SYDNEY SOUTH PLANNING PANEL – SUPPLEMENTARY REPORT

Panel Reference	2019SSH008
DA Number	41/2019
LGA	Canterbury Bankstown Council
Proposed Development	Re-development of Canterbury South Public School including construction of a three-storey building with a capacity of 690 students, one-way kiss and drop link road between Napier Street and France Street, expansion of the France Street car park and associated landscape works (Amended Proposal)
Street Address	10 – 20 High Street, Canterbury
Applicant/Owner	School Infrastructure NSW C/- DFP Planning, Owner: Department of Education
Date of DA lodgement	26 February 2019
Number of Submissions	Seven (7) total - 5 objections, 1 letter of support, 1 request to attend meeting
Recommendation	Approval, subject to conditions
Regional Development Criteria (Schedule 7 of the SEPP (State and Regional Development) 2011	Part 4, Clause 20(1) of the SEPP (State and Regional Development) 2011 the application is declared as regionally significant development. Schedule 7 includes 'Crown development over \$5 million'. The proposed capital investment value of \$17,401,00.00 and falls within this category.

SUMMARY REPORT

Figure 1 Extract of Block C Building Height Plan

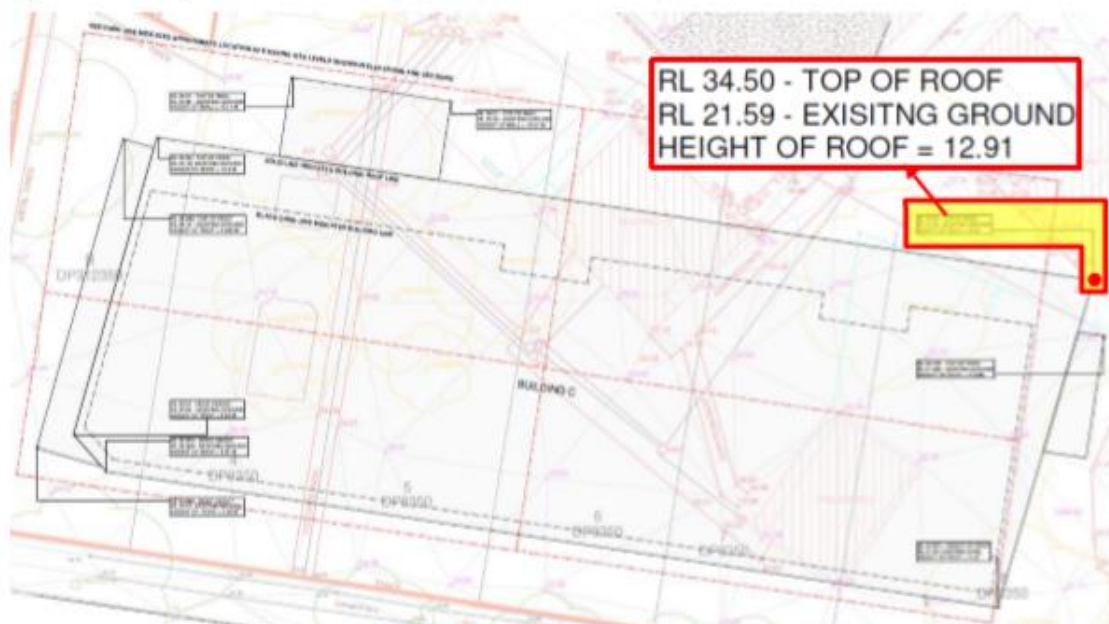
The subject site has a fall from west to south-east of approximately 2.98metres. The height breach ranges from nil (south-west corner) to 12.91m (north eastern corner), a maximum breach of 4.41m (or 51.9%) and is located to the north eastern corner of Building C (i.e. within the site and closet to Pat O'Connor Reserve) this is shown in figure 1 below. The design of the building will make provisions for a new central “Green Square” (central courtyard) and an additional grassed area along the north west corner of the site (adjacent to 22 High Street, Canterbury). The building height in the south west corner (along Napier Street) is between 8.37m-8.46m which meets the building height under CLEP 2012.

As stated above, the highest breach is located at the north eastern corner of Building C, which adjoins the proposed kiss and drop link road at the end of Napier Street, adjoining Pat O'Connor Reserve. Therefore, the height breach will be less perceivable from Napier Street, reducing the impact on the public domain. The height is generally compliant at the western end of Napier Street which is visible from High Street. The bulk and scale of the building as viewed from Pat Connor Reserve is minimised by the increase setback, roof design and overall design of the building.

Given the building design parameters set by the EFSG requirements, the proposal has sought other measures to reduce the height and visual bulk, by removing the clerestory windows and services from the roof. This will ensure that the floor to ceiling heights within the building are not compromised, maintaining the required amenity to the classrooms.
